AUBURN HILLS 13TH ADDITION
WICHITA, SEDGWICK COUNTY, KANSAS

RE: S/D 00-10 -- Final Plat of AUBURN HILLS 13TH ADDITION

At the regular meeting of the Subdivision Committee of the Metropolitan Area Planning Commission on Thursday, March 9, 2000, the above captioned plat was considered. The action of the Committee was to approve the final plat, subject to:

CASE NUMBER: S/D 00-10 -- AUBURN HILLS 13TH ADDITION

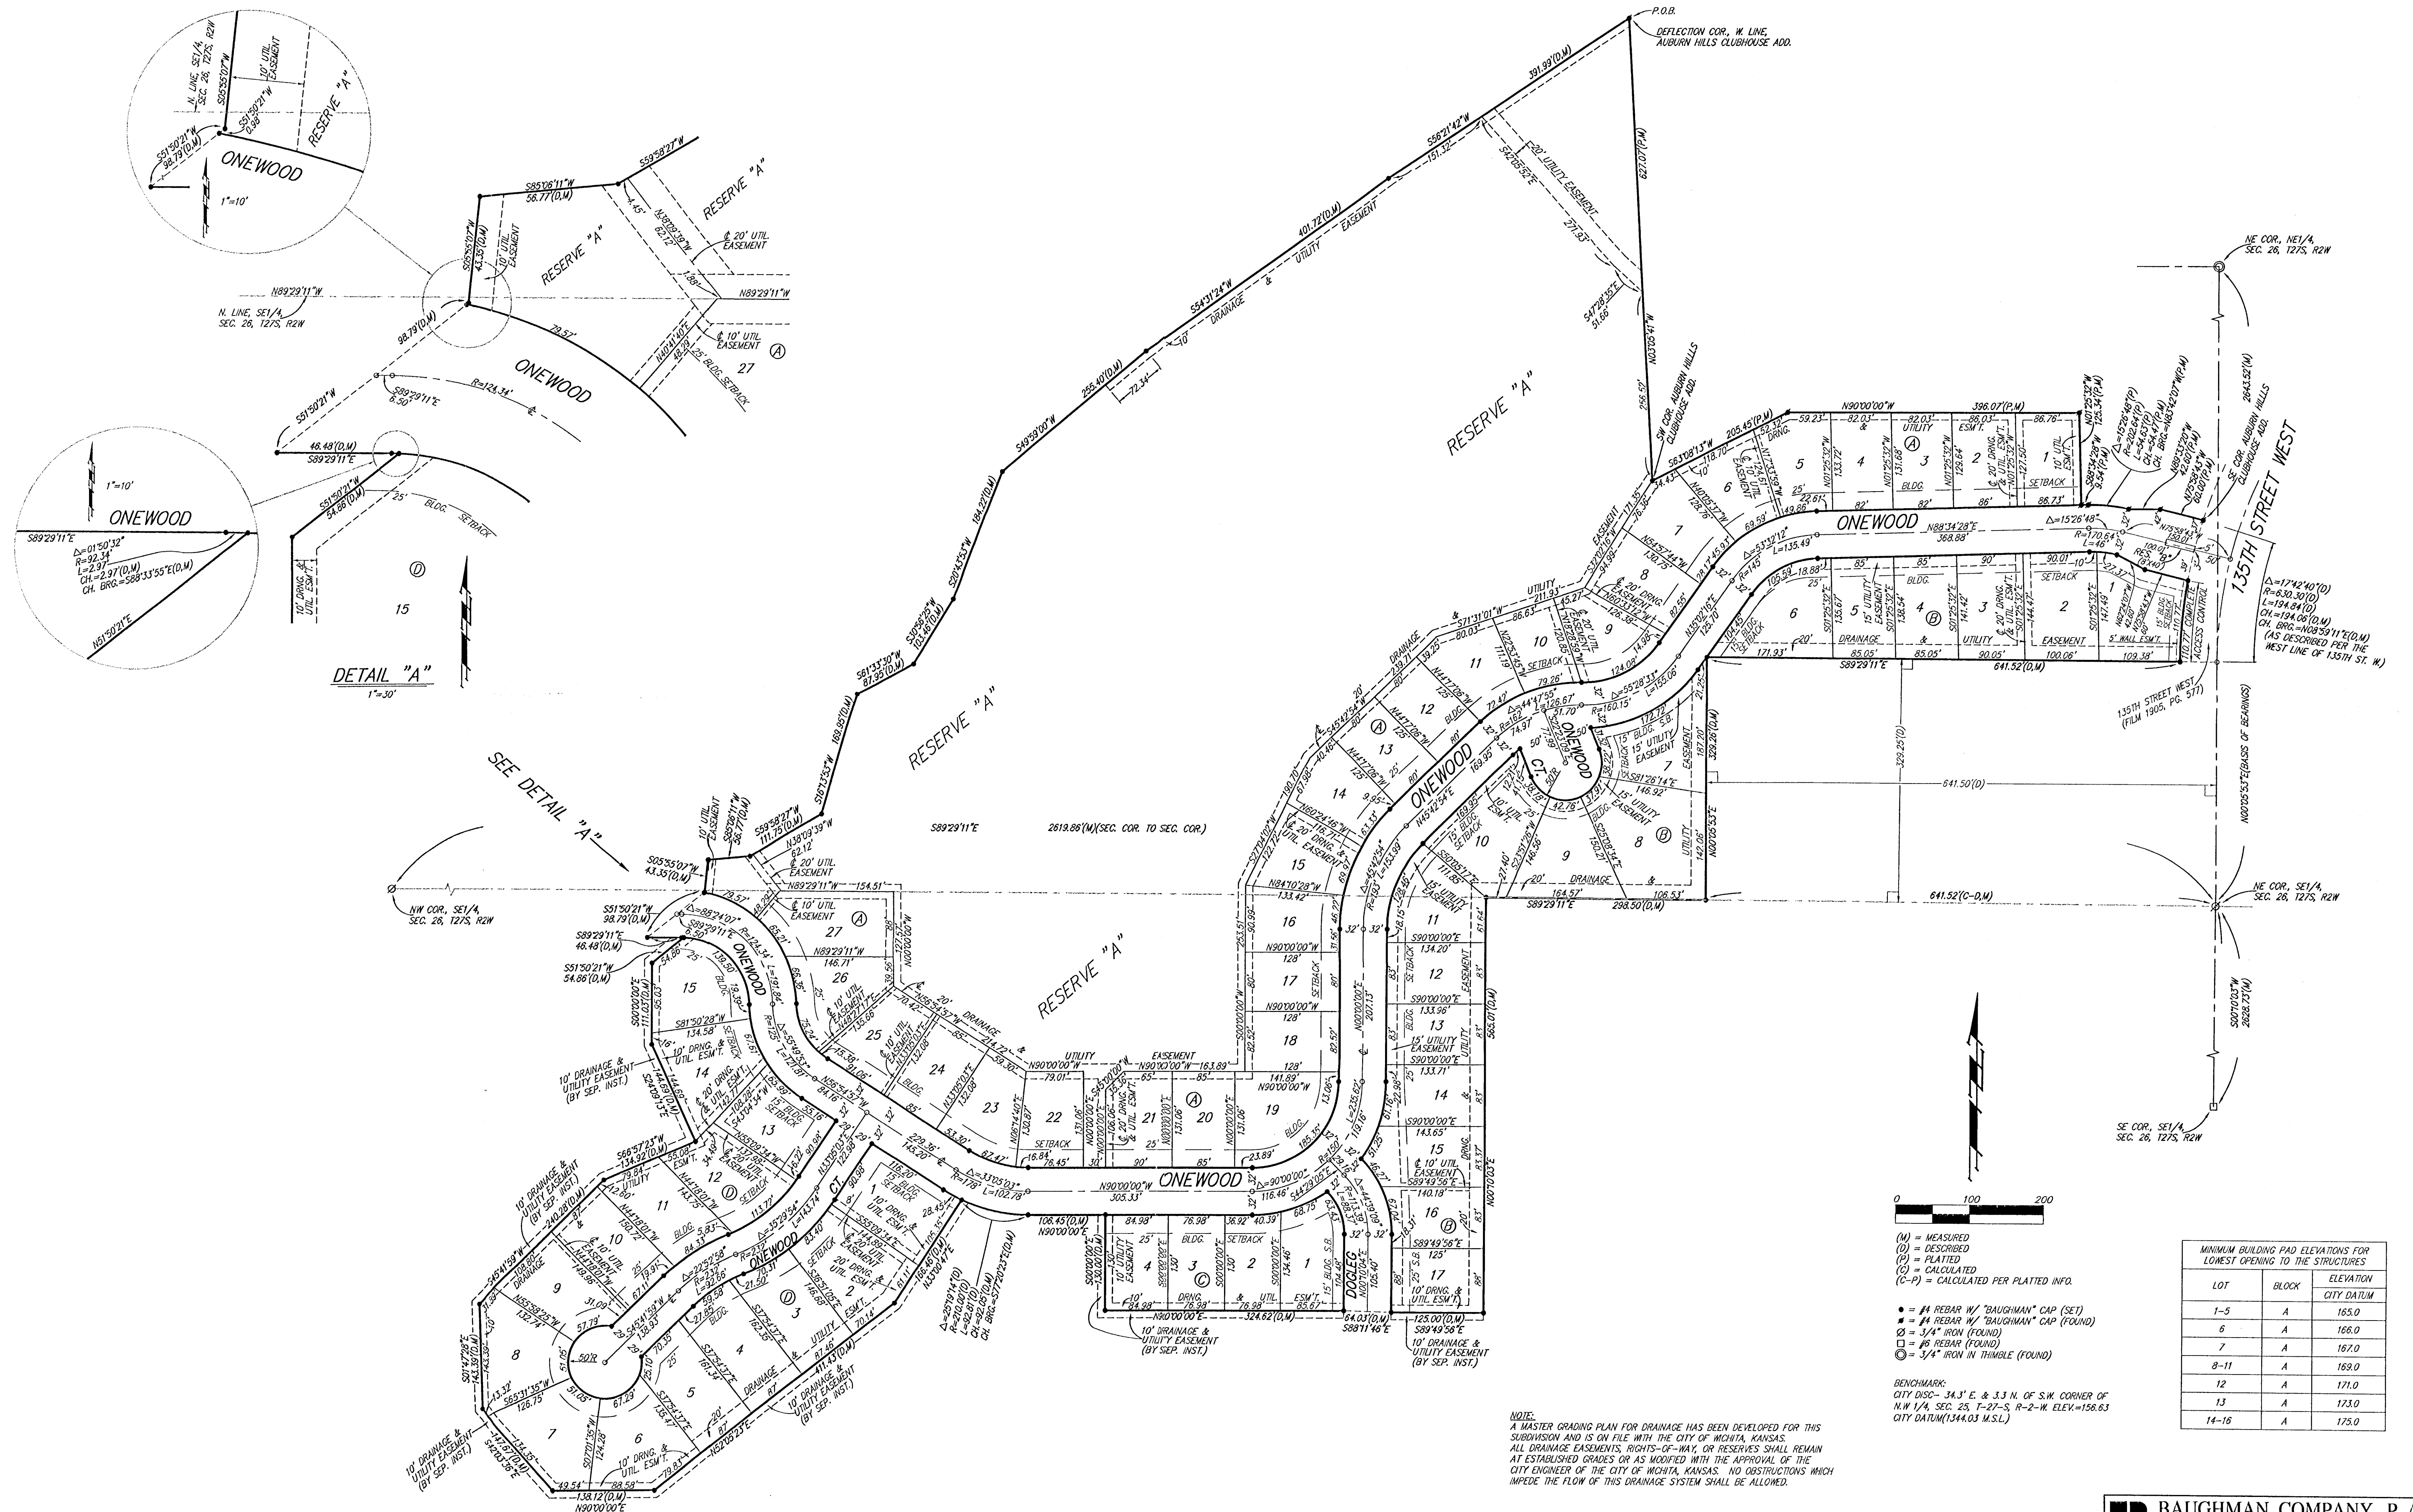
- D. If this site develops before Auburn Hills 12th, a temporary turnaround will need to be provided at the terminus of Onewood to the west and referenced in the plat's text on the final plat.

- I. A definite location needs to be denoted for the utility easement in the northeast portion of Reserve A.
- J. A definite location needs to be denoted for the utility easement northeast of Lot 27, Block A, in Reserve A.

- K. The centerline of Dogleg Street needs to be located at Onewood Street.
- L. Bearings needs to be added for the north line of Lot 1, Block B.
- M. The Applicant is reminded that a platting binder is required with the final plat. Approval of this plat will be subject to submittal of this binder and any relevant conditions found by such a review.

- I. A definite location needs to be denoted for the utility easement in the northeast portion of Reserve A.
- J. A definite location needs to be denoted for the utility easement northeast of Lot 27, Block A, in Reserve A.

- K. The centerline of Dogleg Street needs to be located at Onewood Street.
- L. Bearings needs to be added for the north line of Lot 1, Block B.
- M. The Applicant is reminded that a platting binder is required with the final plat. Approval of this plat will be subject to submittal of this binder and any relevant conditions found by such a review.
